**Attachment C – Stantec RFI Response Memo**

**Reference: PC240002 Private Plan Change Request to the Partially Operative Selwyn District Plan (V2) at 157 Levi Road, Rolleston**

### **Request for Further Information (RFI) – Transportation Response**

This technical note has been prepared in response to the RFI issued by Selwyn District Council on 21 June 2024 for the private plan change request to the Partially Operative Selwyn District Plan (POSDP) (V2) at 157 Levi Road, Rolleston in relation to transport queries 3.1-3.11 raised by Mr Carr following peer review.

Figure 1: Suggested Amendment to ODP Main Access Notation

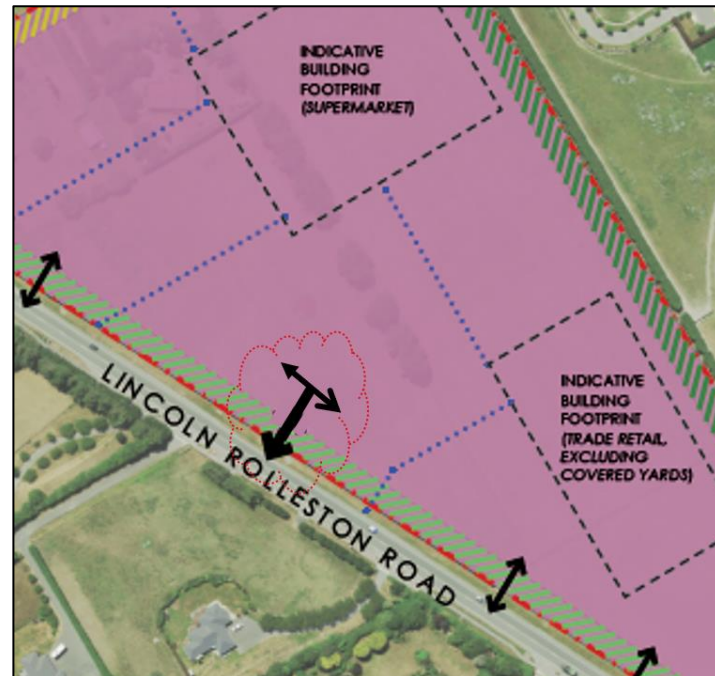
#### **Question 3.1 Internal ODP Vehicle Link**

*“Section 7 notes that there will be joint use of the main site access from Lincoln Rolleston Road to enable vehicles to remain within the site when travelling from one part to another. However no vehicular link is shown on the ODP to provide certainty on this. Should such a link be shown?”*

The ODP needs to provide flexibility to respond to precise site layouts that may evolve through site design processes. The Integrated Transport Assessment (ITA) at Section 12 sets out that development within the site will almost certainly be subject to High Trip Generator assessment which would address internal vehicle and pedestrian linkages as part of a resource consent process to establish a trade retail and trade supply activity. In this case it is proposed that the main access will support development both north and south of the main access from Lincoln Rolleston Road. As such, it is recommended that the access arrow on the ODP shows a split arrow generally as indicated below in **Figure 1**.
